April 17, 2009

Subject: Responses to February 19, 2009, EPA Letter Regarding the LTR Monitored Natural Attenuation (MNA) Summary Report

744 Heartland Trail
Madison, WI 53717-1934
P.O. Box 8923 53708-8923
Phone: 608-831-4444
Fax: 608-831-3334

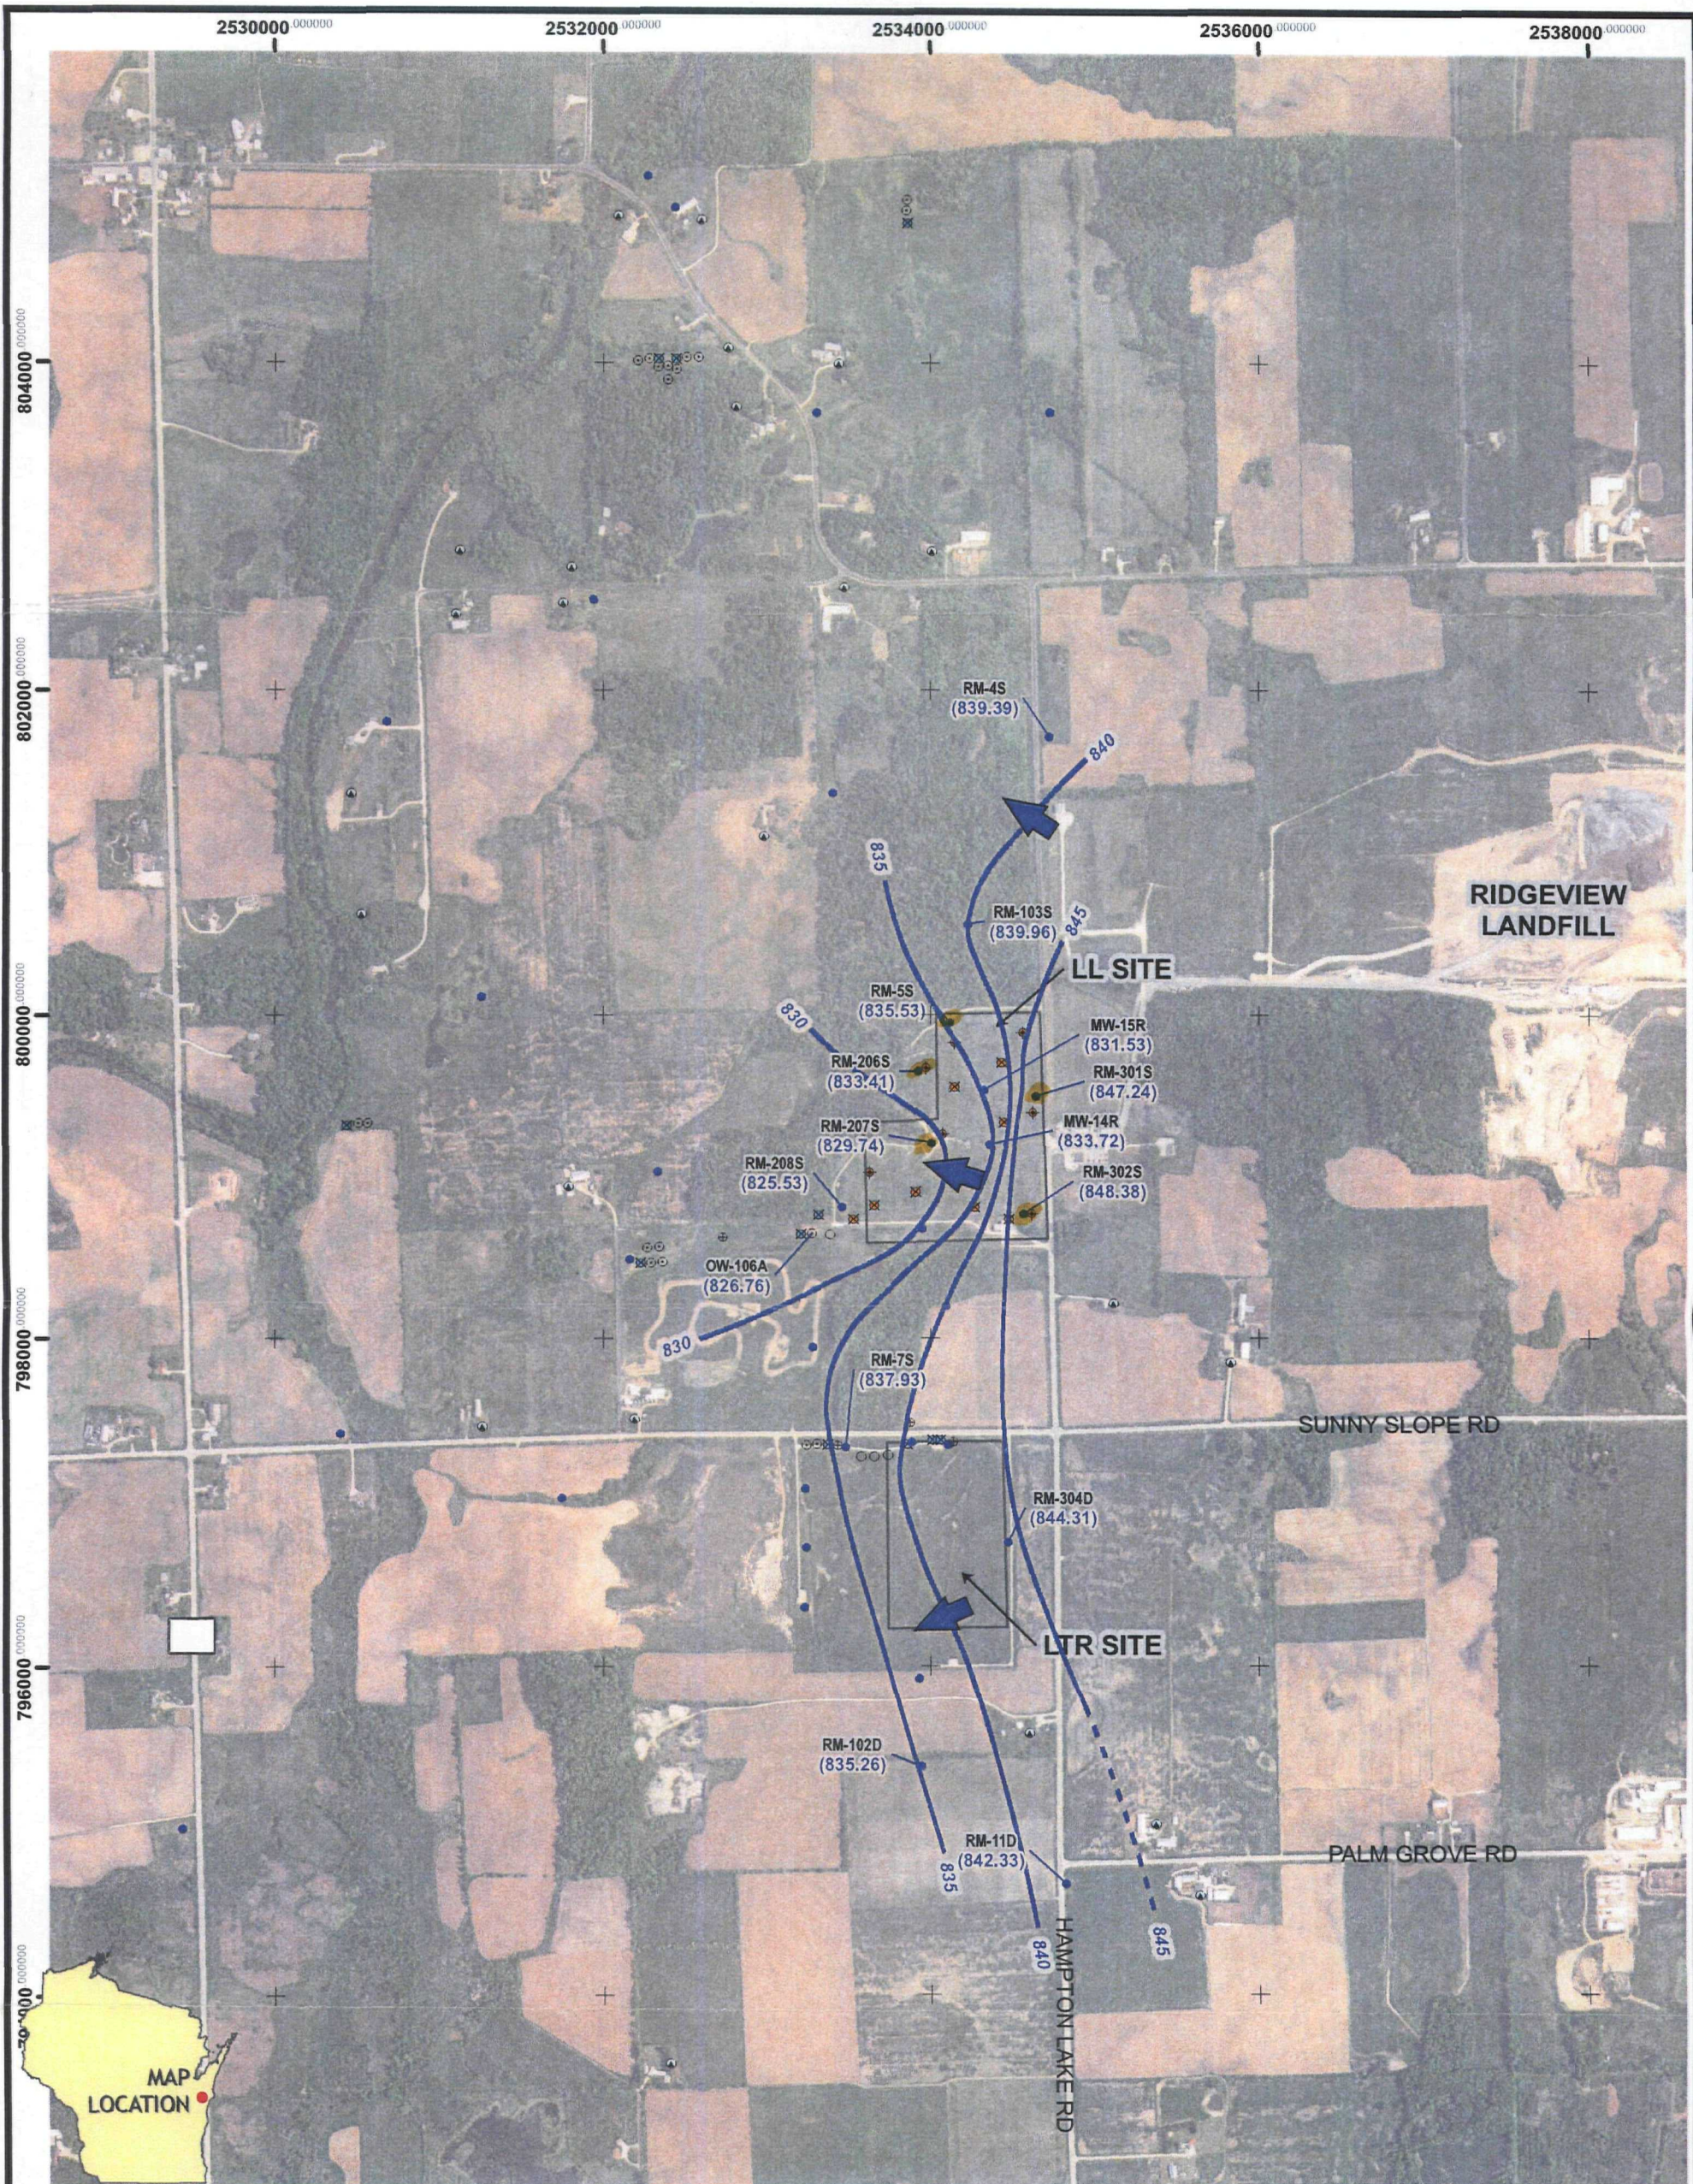
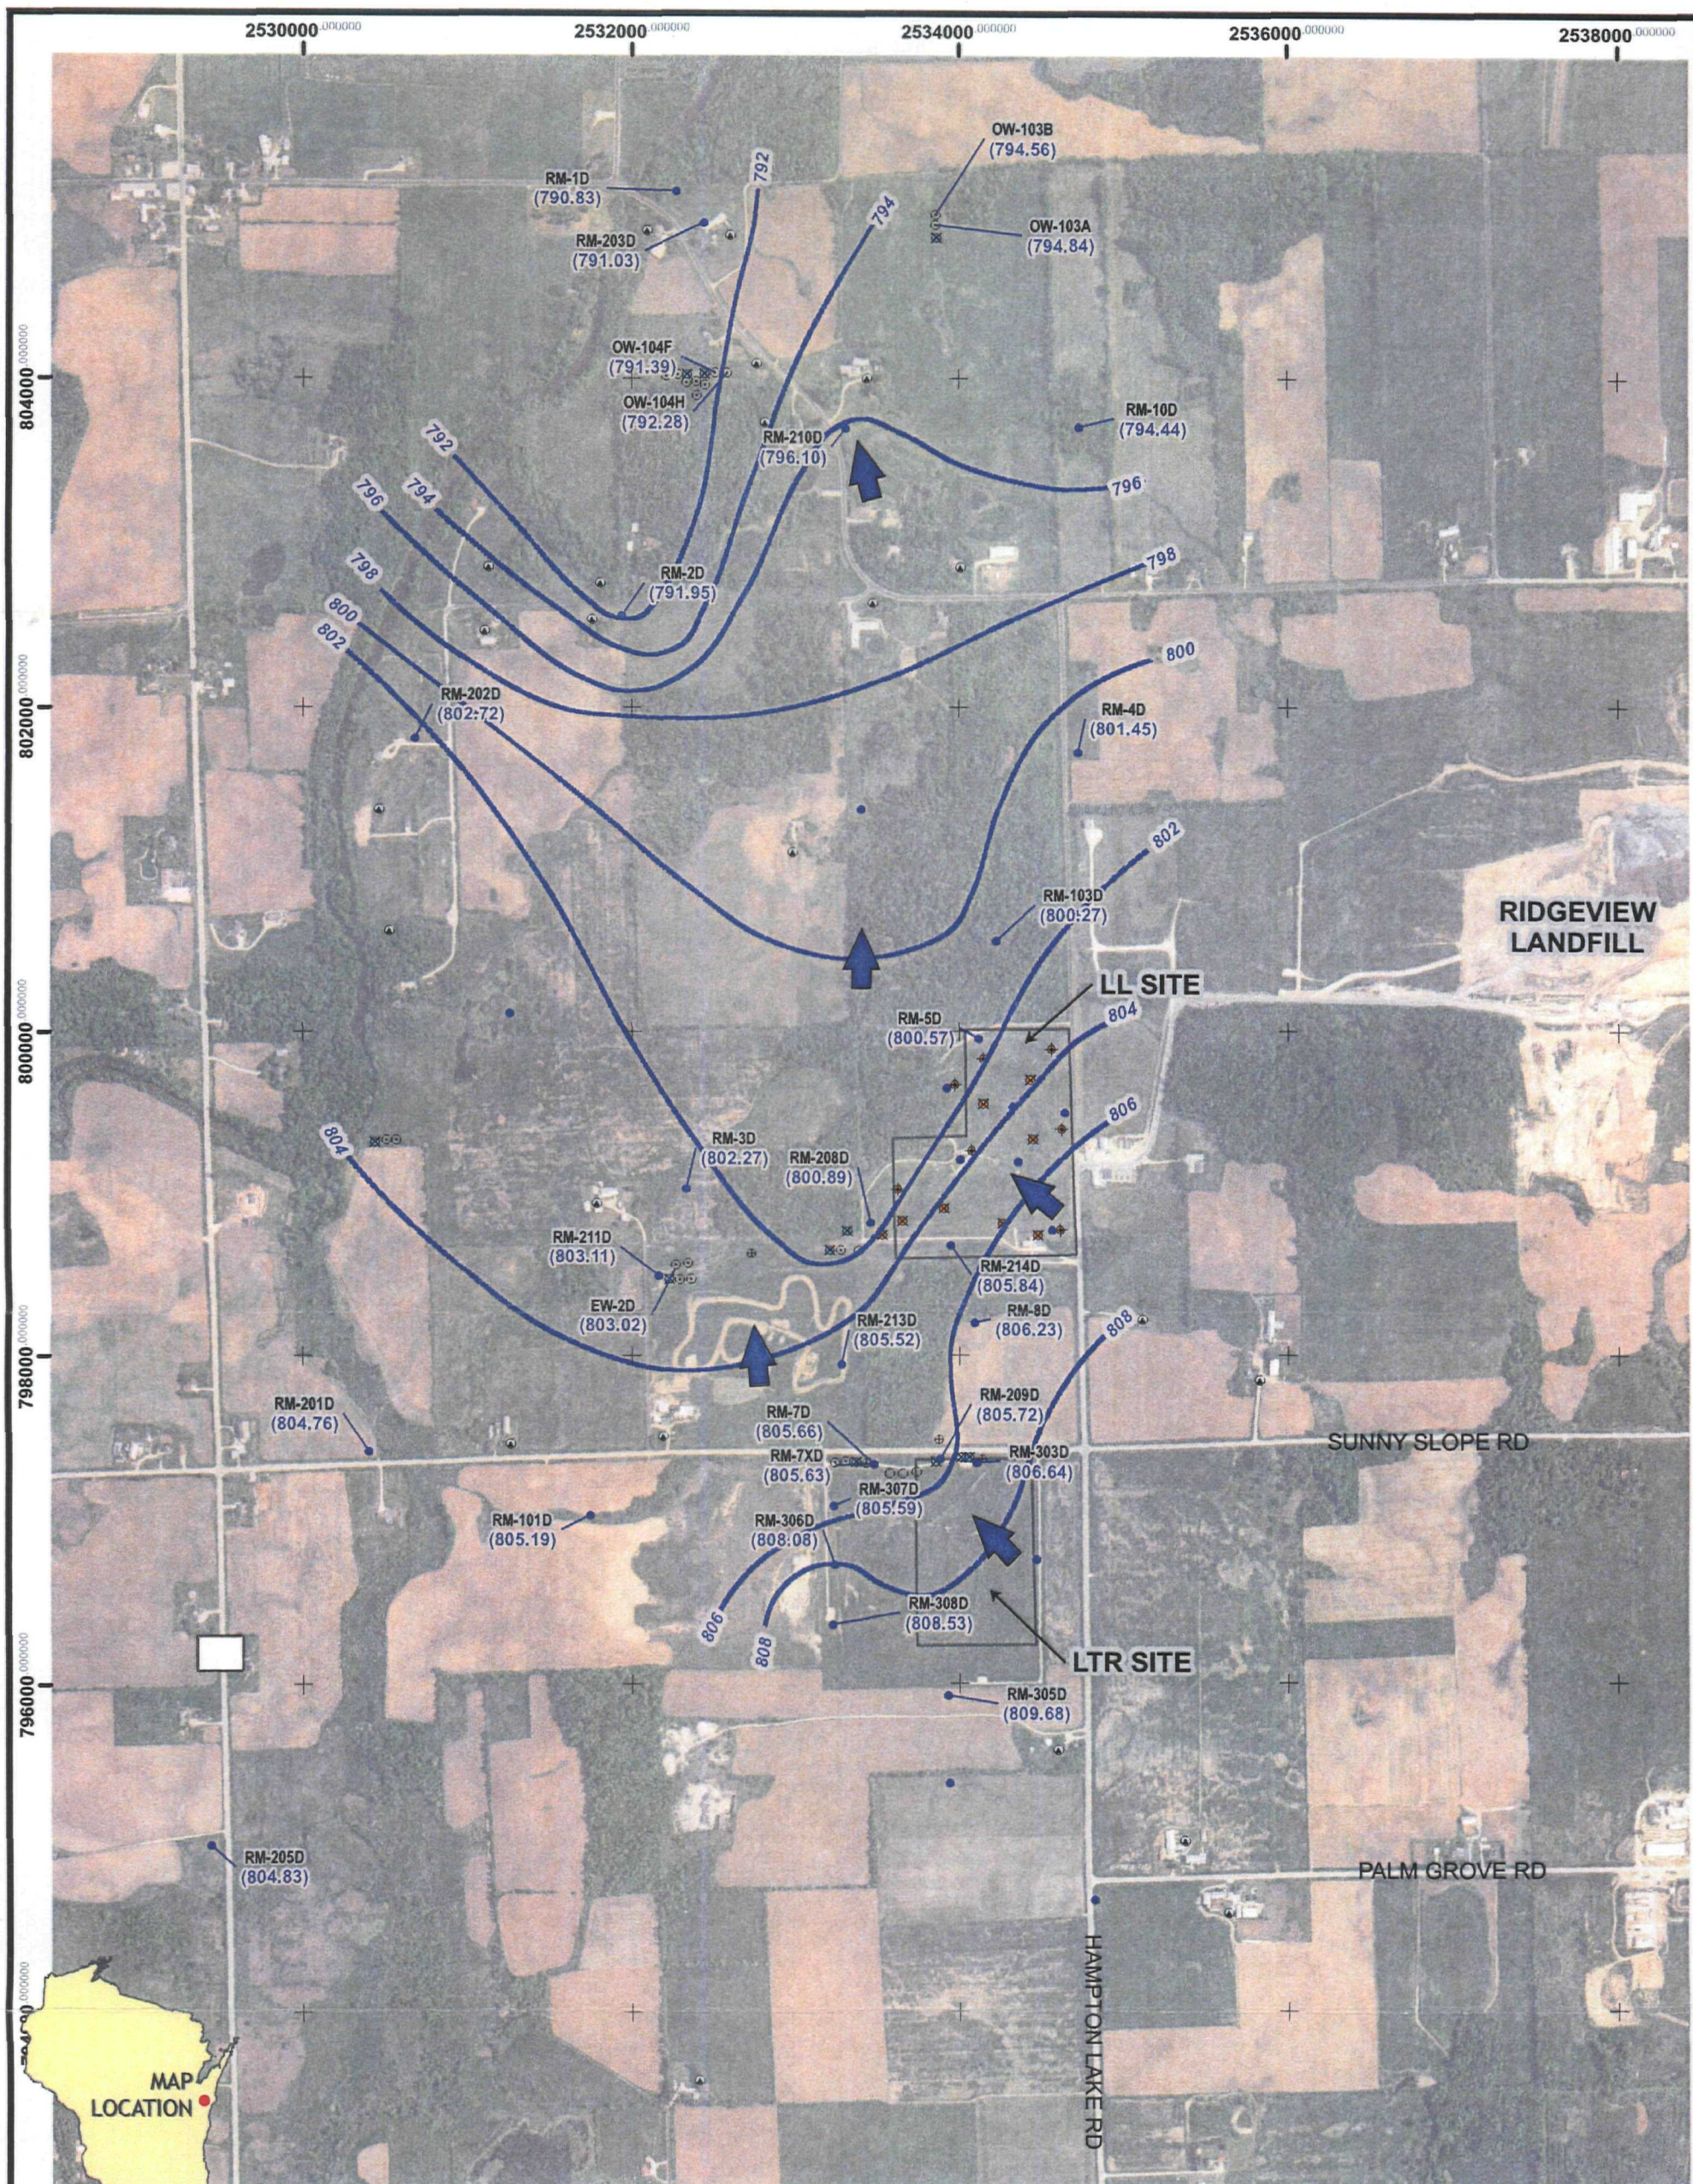
13. *Section 4.1.2: To demonstrate whether groundwater flow directions do or do not change with the season, potentiometric surface maps are needed for a high (spring) and low (winter) water level periods. Only the map for July 2008 was provided.*

Response: RMT has provided additional groundwater contour maps to demonstrate consistent groundwater flow directions (Attachment 4).
